PHAP26-00019

Date: May 7, 2026
Application Type: Certificate of Appropriateness
Property Owner: Laura Gabriela Hernandez Sierra
Representative: Laura Gabriela Hernandez Sierra
Legal Description: 8 Sunset Heights N 120 Ft of 34 & N 120 Ft of W 1/2 of 33 (4500 Sq Ft), City of El Paso, El Paso County, Texas
Historic District: Sunset Heights
Location: 506 W. Yandell Drive
Representative District: #8
Existing Zoning: A-3/H (Apartments/Historic)
Year Built: 1904
Historic Status: Contributing
Request: Reconsideration of an approved Certificate of Appropriateness for installation of a metal roof
Orig. Application Filed: 4/2/2026
Orig. 45 Day Expiration: 5/17/2026

ITEM #4

Reconsideration of an approved Certificate of Appropriateness for installation of a metal roof

PROPOSED ROOFING STRUCTURE

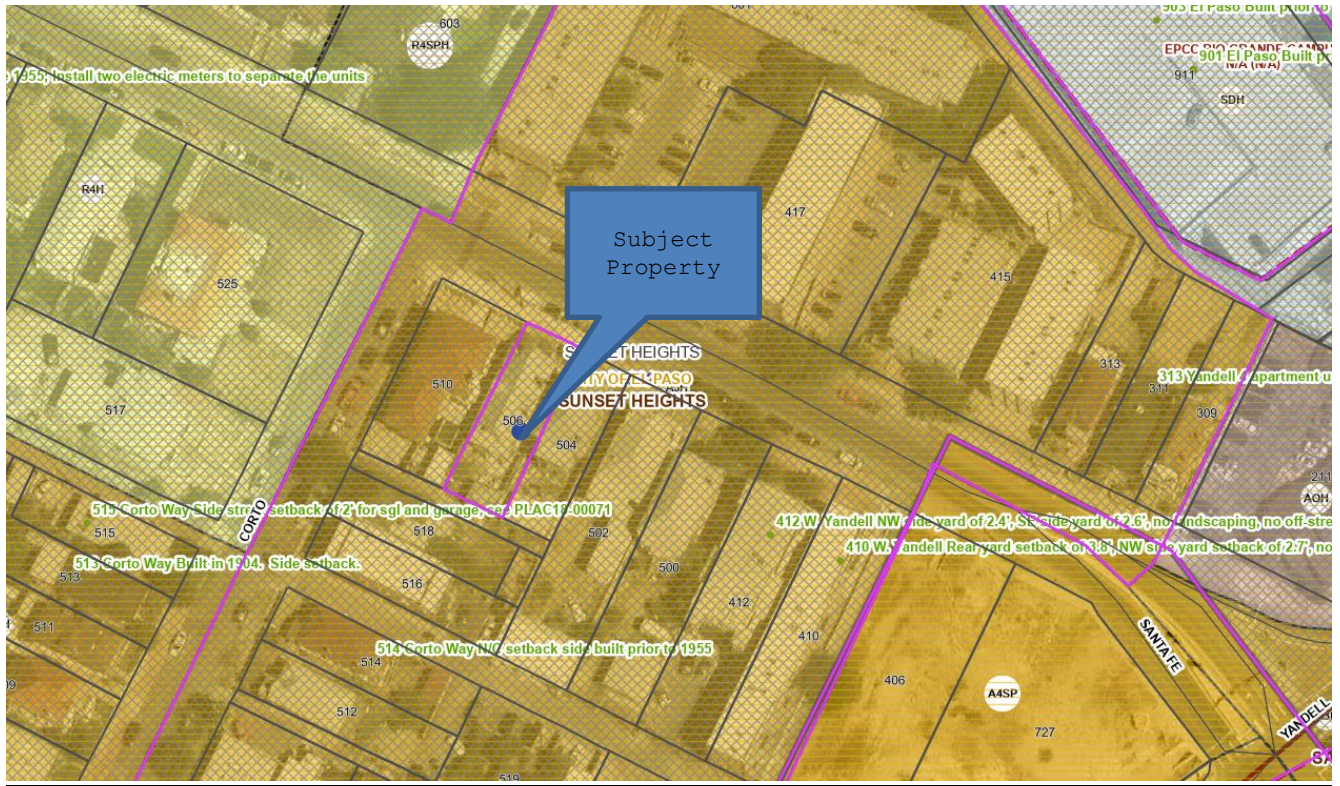
The Historic Preservation Office recommends APPROVAL WITH A MODIFICATION of the proposed scope of work based on the following recommendations:

- *The distinctive features of each roof type should be retained as they are character-defining elements. If a roof requires repair, the replacement materials must match the original or existing materials as closely as possible. Do not change the style or construction of the roof.*

- *Deteriorated historic features will be repaired rather than replaced. Where the severity of deterioration requires replacement of a distinctive feature, the new feature will match the old in design, color, texture and, where possible, materials. Replacement of missing features will be substantiated by documentary and physical evidence.*

The modification is that the new roof be of a metal in the shape and pattern of shingles to resemble the original roof.
